**RE: SHERWOOD FOREST ~ LOT 159
159 Friar Tuck Hill
Annapolis MD, 21405
Variance Application**

VARIANCE PLAN
SHERWOOD FOREST ~ LOT 159
 159 FRIAR TUCK HILL, ANNAPOLIS, MD 21405
 TAX ACCT. NO. 02-720-07550319
 TAX MAP 0039 GRID 0019 PARCEL 0295 DISTRICT 2nd
 ANNE ARUNDEL COUNTY, MARYLAND

CONFIRMATION OF PRE-FILE

PRE-FILE #: 2024-0083-P
DATE: 08/28/2024
OPZ STAFF: Jennifer Lechner
Kelly Krinetz

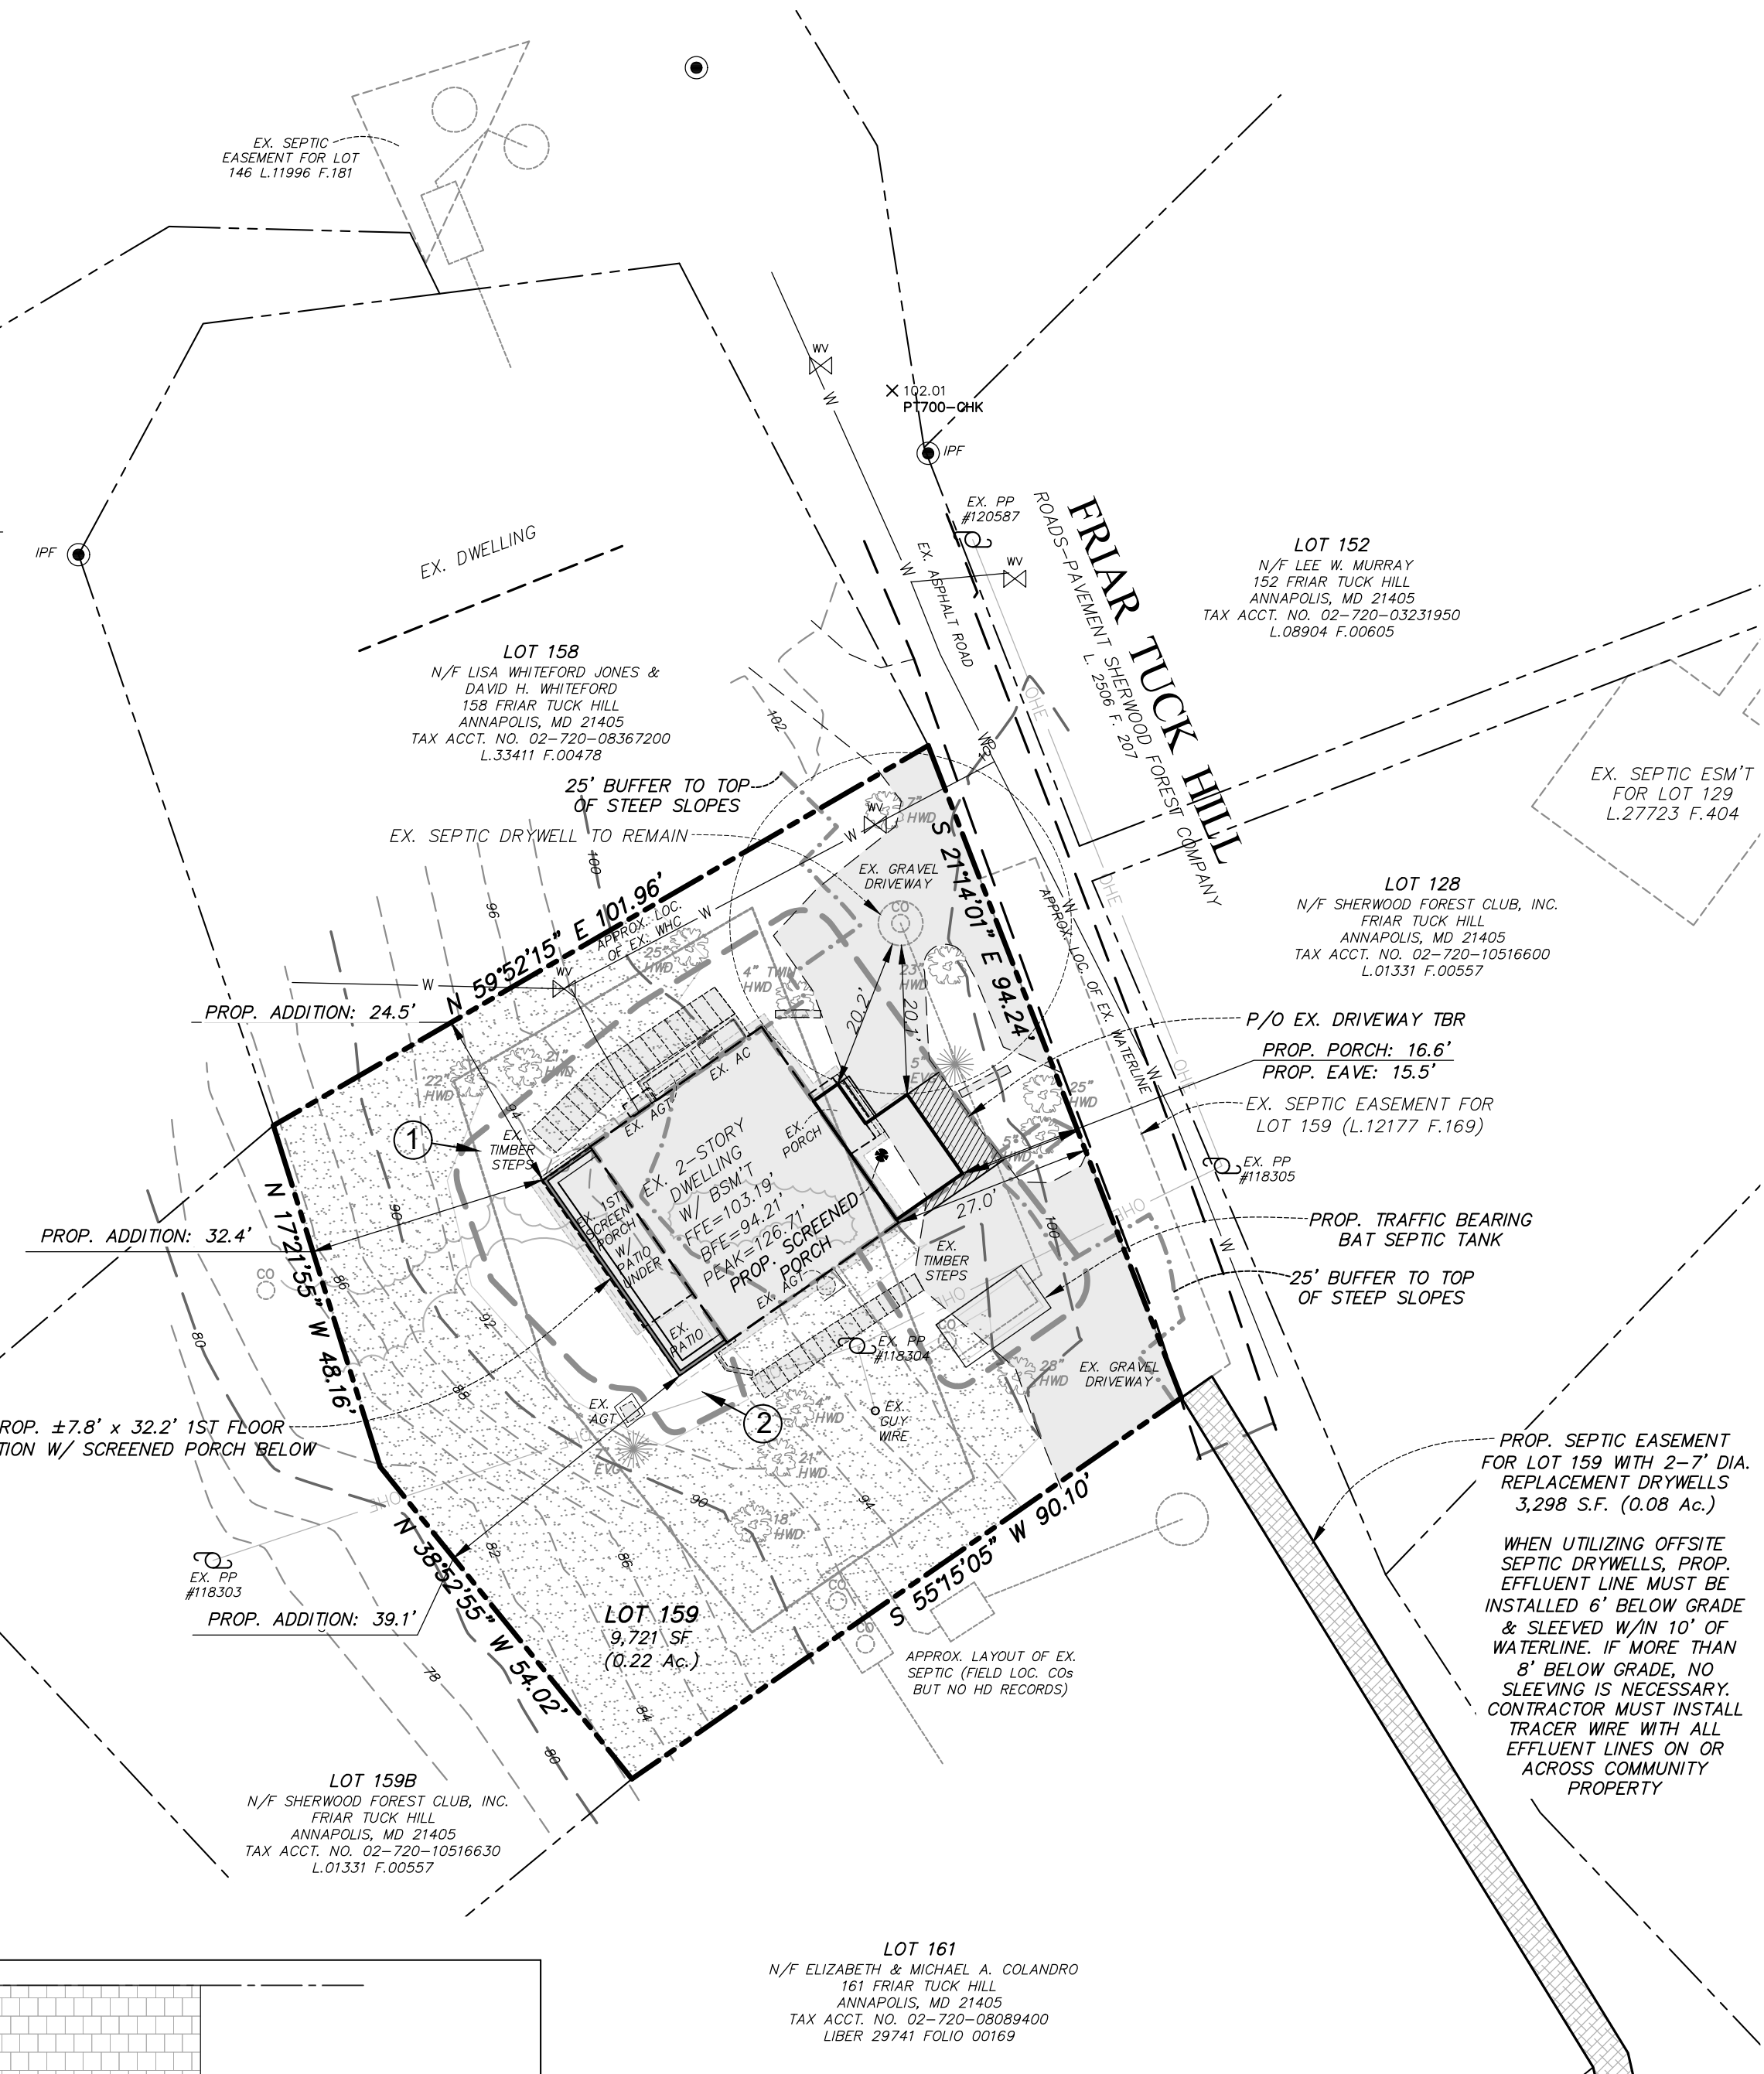
The Administrative Site Plan should indicate the dimensions (length, width and height) of the proposed addition and screened porch, the setbacks of the proposed construction to all lot lines, and indicate if the area under the existing screened porch/proposed addition will be developed.

The existing dwelling sits at the top of a 45% slope.

There is no objection to the proposed improvements at the front of the dwelling.

Provided the applicant can meet the variance approval standards, this Office recommends limiting the improvements to the rear of the dwelling to the existing footprint of the patio/existing screen porch with no additional expansion. A steep slope Modification will be required.
